# GSR TPMS Testing – validation of proposed amendments to R141 13-20 July 2020 Study on behalf of the European Commission

# Open questions for defining the test procedure

# Tyre deflation – how long does it take ?

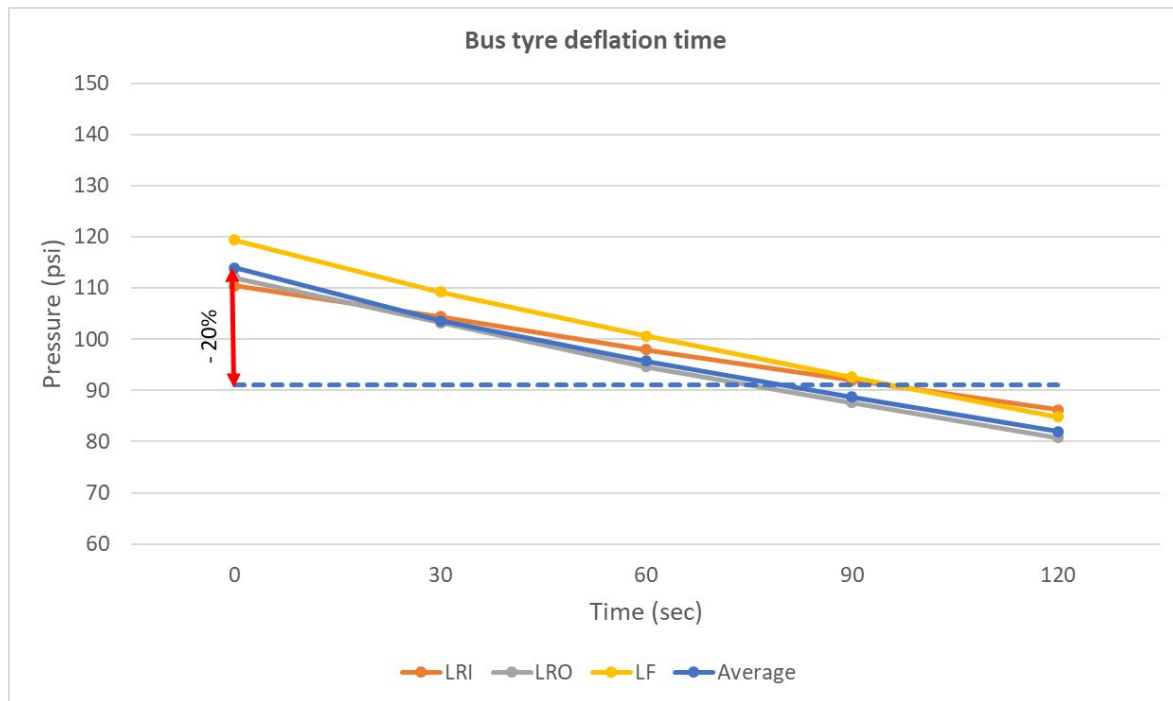
Deflation times for -20% were measured in the diffusion tests:

6 tyres / 2 people = 10:53 mins

8 tyres / 2 people = 13:48 mins

$\Rightarrow$  3.5 mins / tyre / person

# Tyre deflation – temperature / pressure effects with time

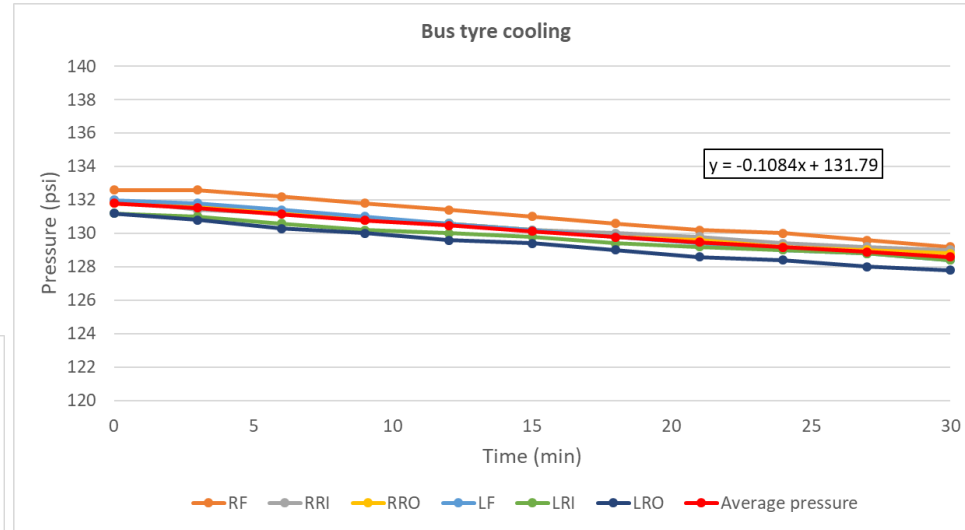
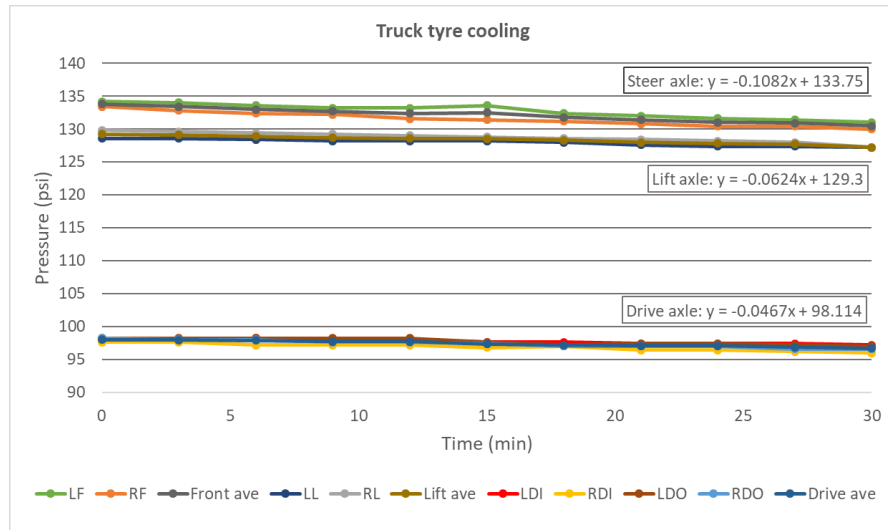
## Bus and truck cooling

Bus:  
Reduction of 3 psi  
average in 30 mins  
= 0.11 psi / min

Reductions of 1.1 – 2.9 psi  
= 0.05 – 0.11 psi / min  
= 0.6 – 1.1 % in 15 min

Deflate **all** tyres within five minutes of measuring the warm pressure as described in paragraph 2.4.3. above **for vehicles of category M1 and N1 and 15 minutes for vehicles of category N2, N3, M2, M3, O3 and O4**, until the deflated tyres are at  $P_{warm} - 20$  per cent, plus a further deflation of 7 kPa, namely  $P_{test}$ . Following a stabilisation period of between two and five minutes, the pressure  $P_{test}$  shall be rechecked and adjusted if necessary.

Truck and trailer diffusion test

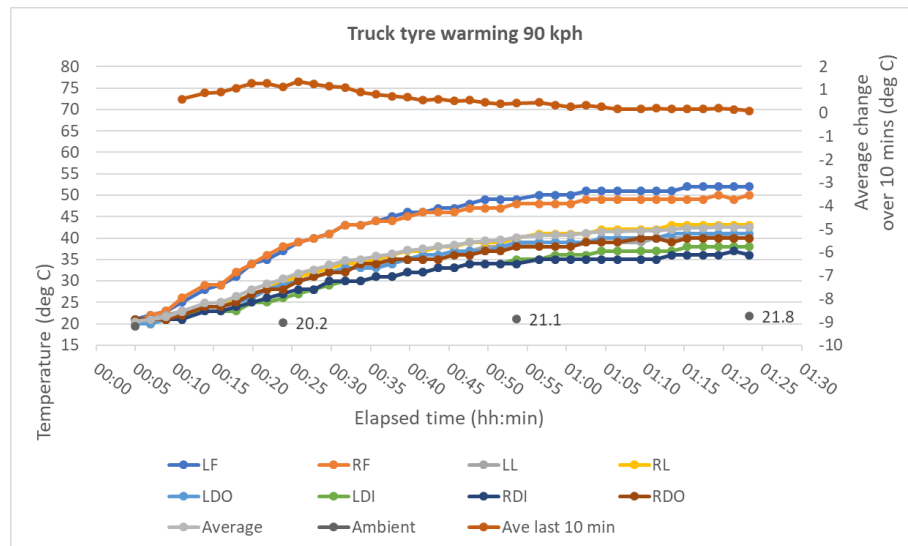
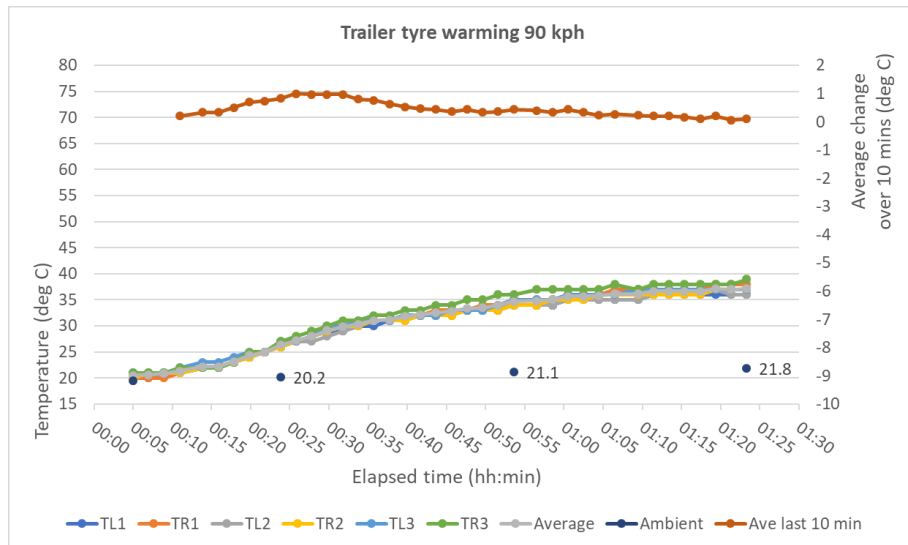
Temperatures stabilise after ~ 1 hour

Bus tests compared:

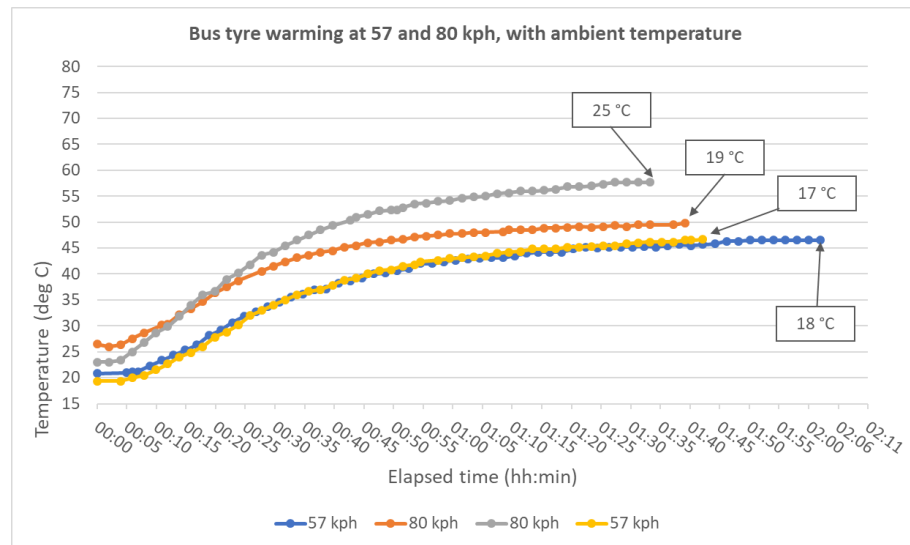
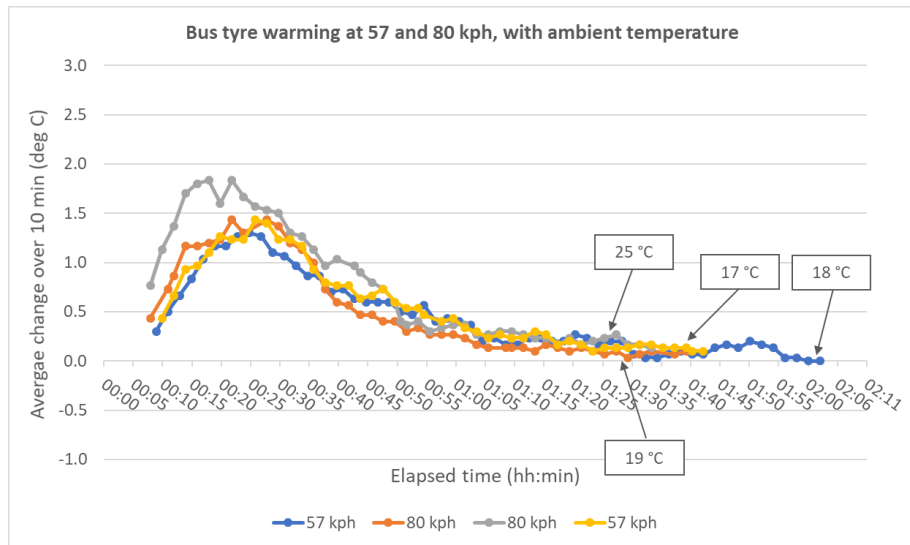
Temperatures stabilise after

~ 1.25 – 1.5 hour

Speed effect is insignificant

Ambient temperature adds to the tyre temperature

**For vehicles of category N2, N3, M2, M3, O3 and O4, drive the vehicle for a minimum of 180 minutes at a speed of fifty-seven km/h  $\pm 10$  km/h.**

*180 minutes to allow for variations in vehicle type and ambient conditions.*

*57km/h as mid-point of speed range*
